**Historic Architectural Review Commission
Staff Report for Item 3**

Application Number: H16-03-0033

Address: #724 Caroline Street

Description of Work:

1948 Sanborn Map

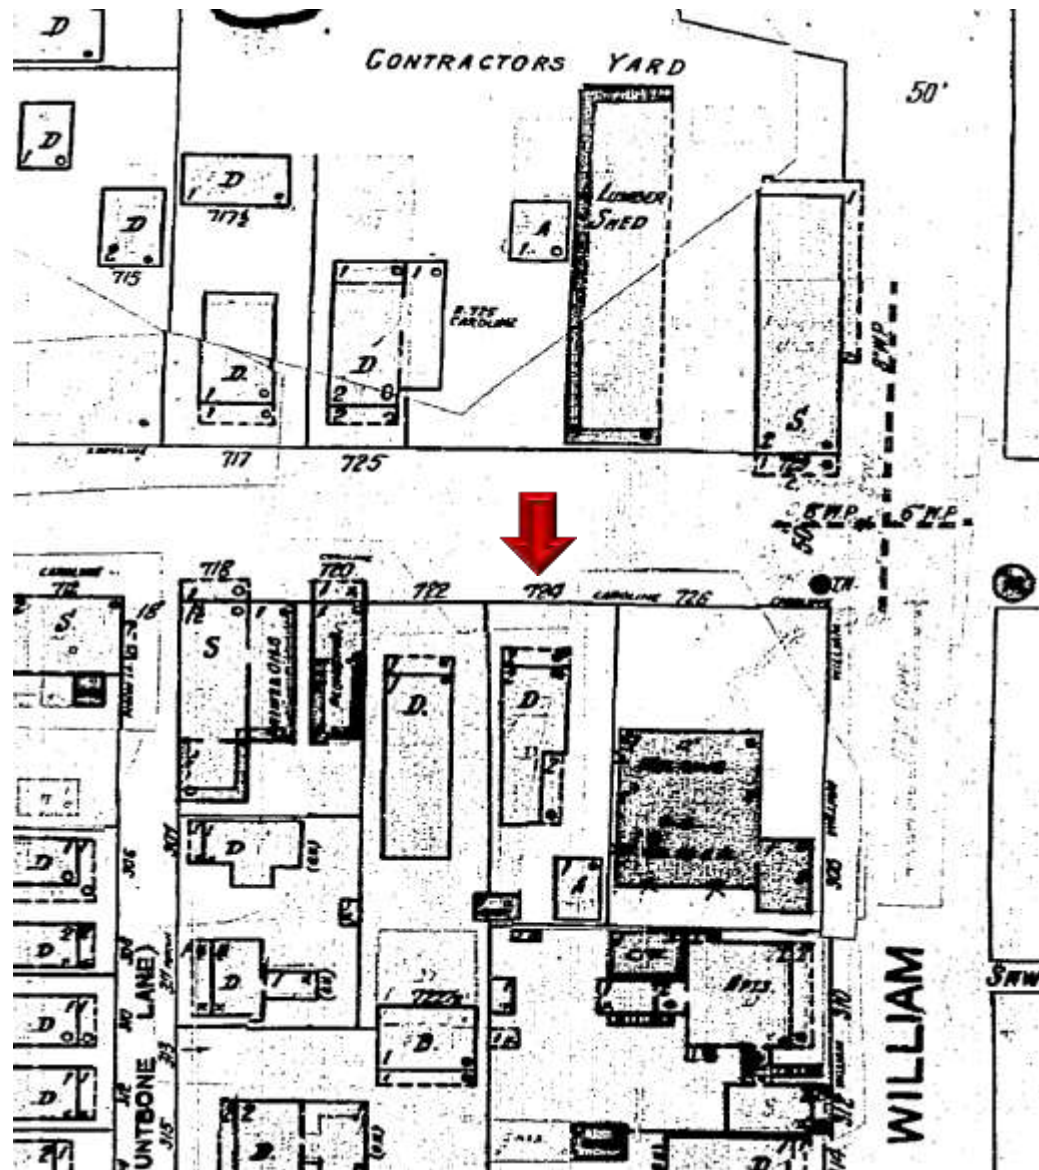
It is important to mention that staff has studied available information regarding the above ground cistern - “concrete shed” on the survey, that is proposed to be demolished. The Sanborn maps from 1899 through 1948, depict a cistern on the rear yard of the property. The 1948 color-coded Sanborn map depicts the cistern in blue color, which means that the structure is in concrete or masonry. The 1962 Sanborn map does not portrait any accessory structure on the site. The separation between the cistern and the historic rear footprint of the house in the Sanborn maps versus the location of the “concrete shed” in the survey are very similar. In addition, the construction materials are definitely more than 50 years old. It is evident that the height of the structure was altered through time and that the old mango tree roots have done some damage to the structure. For those reasons, staff will consider and review the request for this structure to be demolished as a historic resource.

Color-coded 1948 Sanborn map.

SITE DEMOLITION PLAN

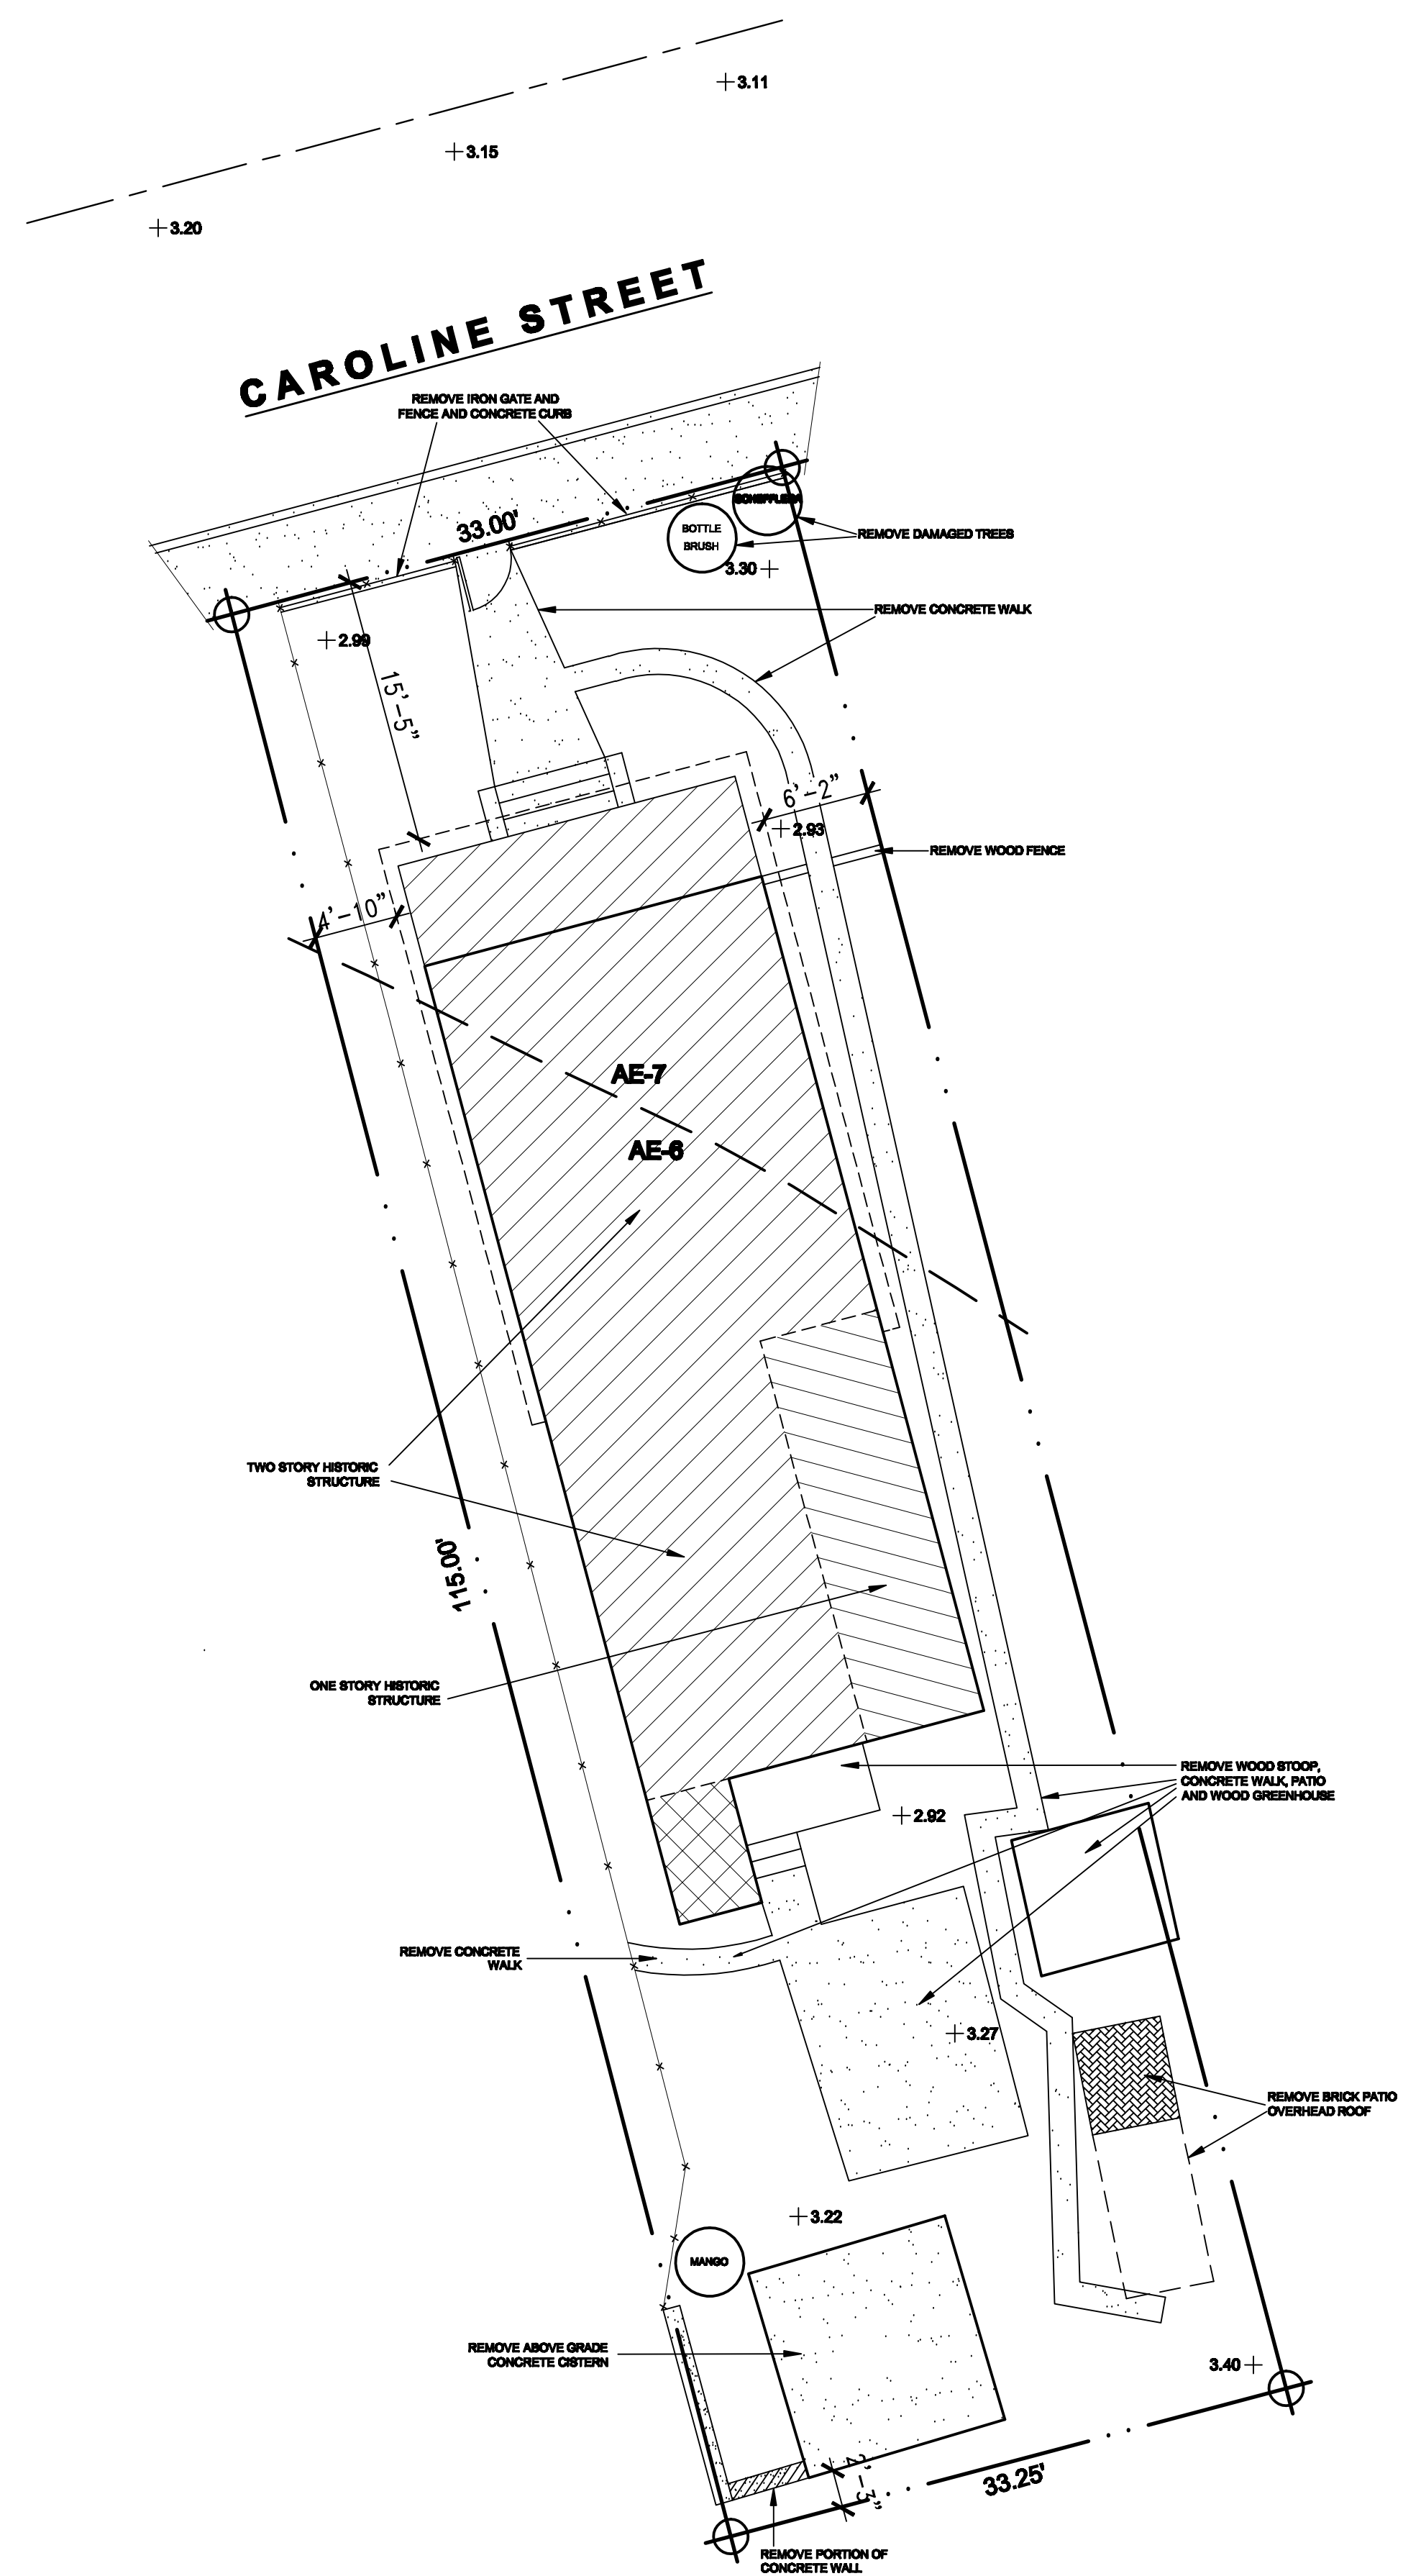
Demolition of rear wall end one-story rear addition. Demolition of cistern, greenhouse, and overhead roof structure at the rear yard.

The plan includes the demolition of several non-historic elements found in the rear of the site. At the time of this report the greenhouse, which was a non-historic structure made with wood lattice, has been already removed.

The structure in question is not irrevocable compromised by extreme deterioration. There are some cracks due to the mango tree root system. The cistern has a wooden gable roof with metal v-crimp.

In conclusion, it is staff's opinion that the Commission can consider the request for demolition proposed in the plans as they comply with the criteria for demolition stated under the Land Development Regulations.

If the Commission approves the demolition of the above-grade cistern, a second reading will be required. If the Commission approves the request for demolition of the one-story structure attached to the rear of the house and an overhead accessory structure on the rear yard, this will be the only required reading.
